Memorandum

Subject: Interim Notice – HDX Heater Actuator

Date: April 29, 2010

INTERIM NOTICE

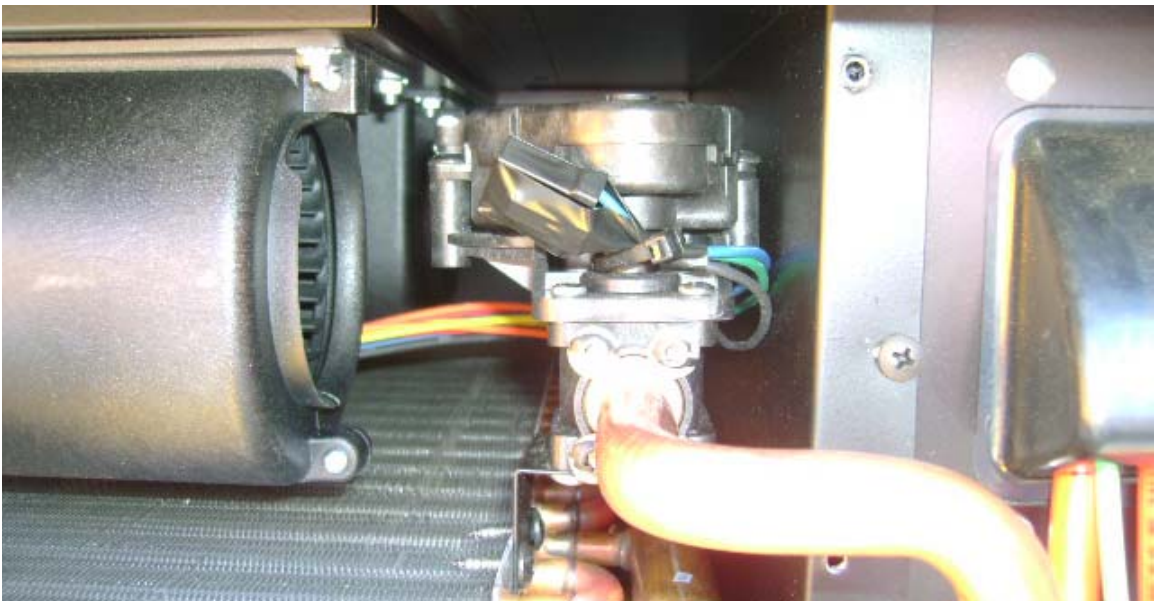
1. Turn the ignition key to the "On" position.
2. Select desired "Full Time" temperature on heater controller. After performing this procedure, the temperature will be fixed at this one setting. If body heat is not required close the heater shutoff valves in the engine compartment.

3. Wait 30 seconds after selecting, then turn ignition key "Off".
4. Remove heater access panel and locate the heater temperature actuator.

5. Disconnect the wire harness from the temperature actuator. The connector is behind the actuator body and has a lock button that must be depressed so it can be pushed up. Please be careful with the heater core fins.

6. Move the loose harness beside heater core, away from fan intakes. Protect the connector with electrical tape as power is still present in the connector housing. If the connector has signs of melting, remove connector and tape off individual wire leads. Secure with a tie strap straddling the plastic portion of the valve body, and ensure that all wires are not disturbed and will not chafe.
